FORD:

2005-2007 F-Super Duty

This article supersedes TSB **07-5-7** to update the Parts.

TSB 07-10-10 (Continued)

Figure 1 - Article 07-10-10

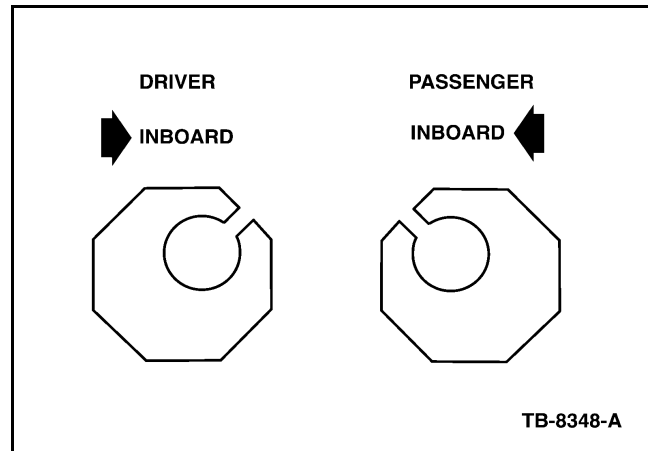
- Rotate the alignment adjustment bushing so that the bushing hole is in the 45 degree forward and inboard position. (See Figure 1)

- This should lower the caster, while keeping the camber within the specification range. If the camber is not in the specification range than rotate the alignment adjustment bushing as needed.
- The final caster and camber settings must be within the specification limits.
- Maintain the current front camber, cross-camber and cross-caster settings as close as you possibly can.
- Adding weight behind the rear axle lowers the rear of the vehicle, which decreases the frame angle, which in effect increases caster.
